19 November 2019

218963

Modification Application to SSDA 5249-2012 1 Lawson Square, Redfern

Figure 2 Eastern elevation of the proposed rooftop terrace, including privacy structure

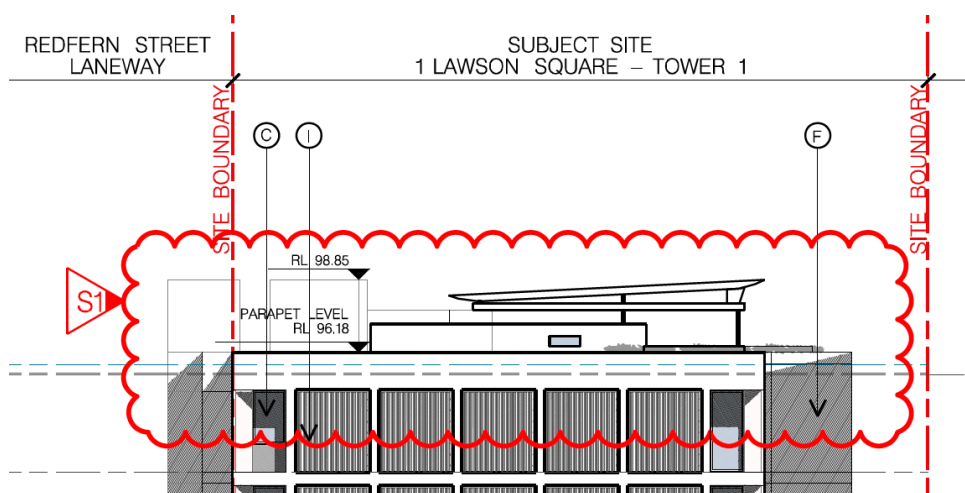
It is proposed to convert the previously inaccessible rooftop of Tower 1 to a new private outdoor terrace for use of the residents of apartment 17.01 (see **Figure 2** and **3**). This rooftop terrace is similar in design and operation as the existing rooftop terrace on Tower 2 and comprises new outdoor seating area with boundary landscaping and a spa. A new privacy screen will be constructed over the rooftop terrace, with a maximum height of 98.85m consistent with the existing rooftop plant and lift overrun that border the terrace to the south.

Figure 4 View analysis of a bedroom looking at the eastern side of Tower 1 on Level 18

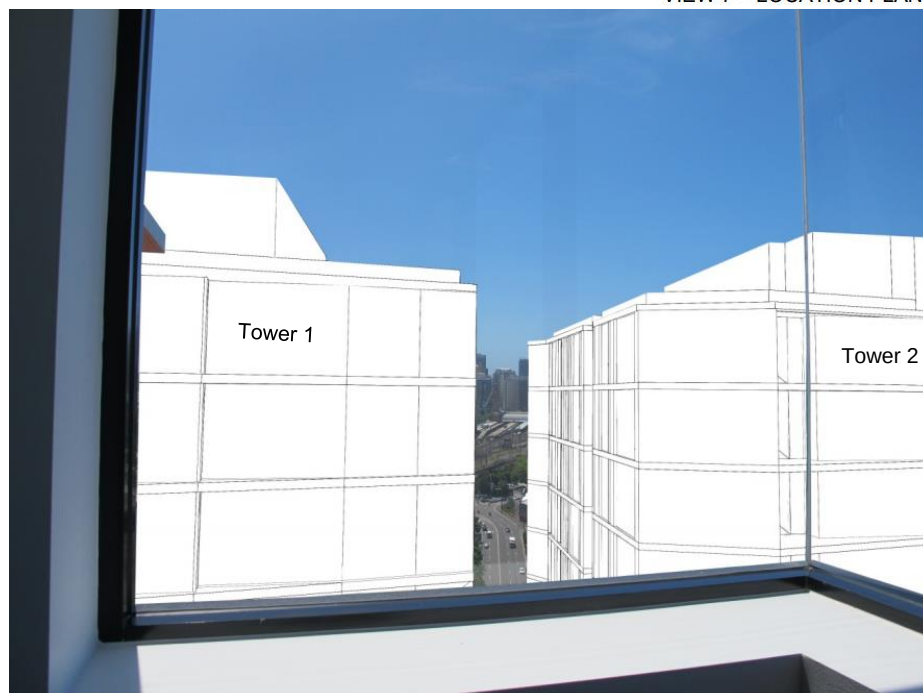
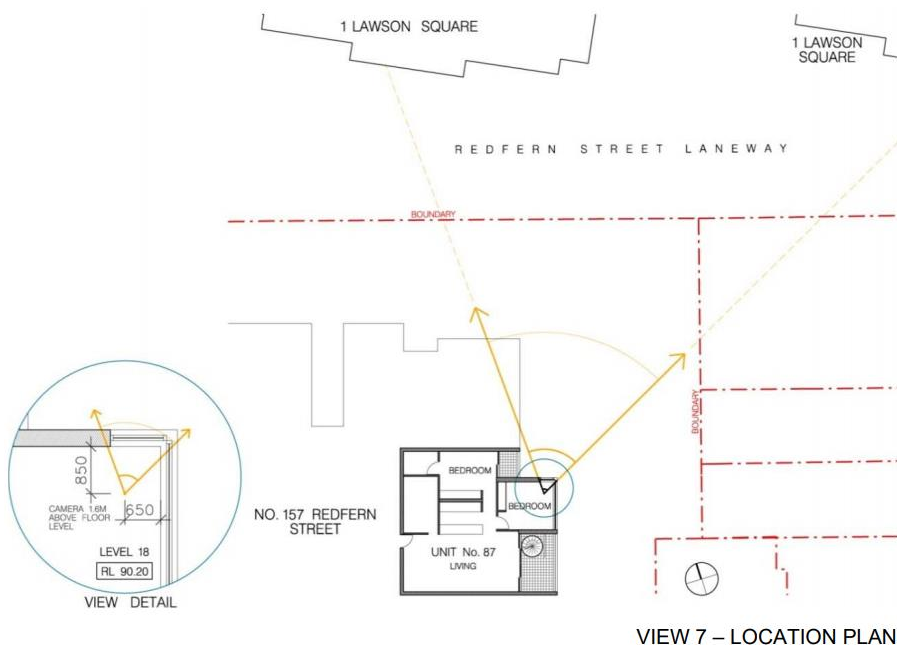
The proposed modifications will also not adversely impact view sharing. The proposed rooftop privacy structure will not be taller than above the existing rooftop plant and lift overrun and is substantially screened by these existing rooftop elements. The privacy structure will extend slightly to the east of the plant/overrun, however, it will not adversely impact view sharing from development to the south at 157-161 Redfern Street, Redfern. In this regard, the view analysis completed as part of the SSDA for the Lawson Square Towers (9259-2012) has been reviewed, which demonstrates that the privacy structure will only potentially obscure a small proportion of sky and not any existing or iconic views (see **Figure 4** below). The overall extent of change will be minor.
